# Service Alert

<b>Subject:</b> <b>BUTTON CELL BATTERY SIZE FOR NEW REMOTE TRANSMITTER DIFFERENT THAN PREVIOUS REMOTE TRANSMITTER</b>	<b>Service Alert No.:</b> SA-046/19
	<b>Last Issued:</b> 11/05/2019

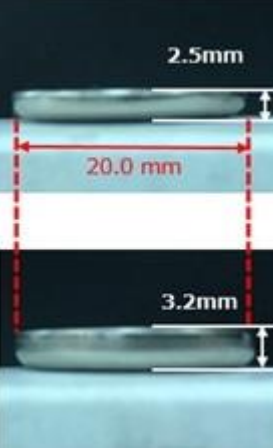
On the 2019 Mazda3 (BP) and all 2020 Mazda vehicles (except CX-3), the CR2032 button cell battery is required for the new type remote transmitter. If it is mistakenly replaced with the conventional CR2025 used in the previous type remote transmitter, it may cause a malfunction.

Verify the button cell battery type before replacing it.

Remote Transmitter	Button Cell Battery		Type	Size	Capacity
<p>Previous Type</p> 			CR2025	D 20.0 x 2.5 mm	160 mAh
<p>New Type</p> 			CR2032	D 20.0 x 3.2 mm	225 mAh
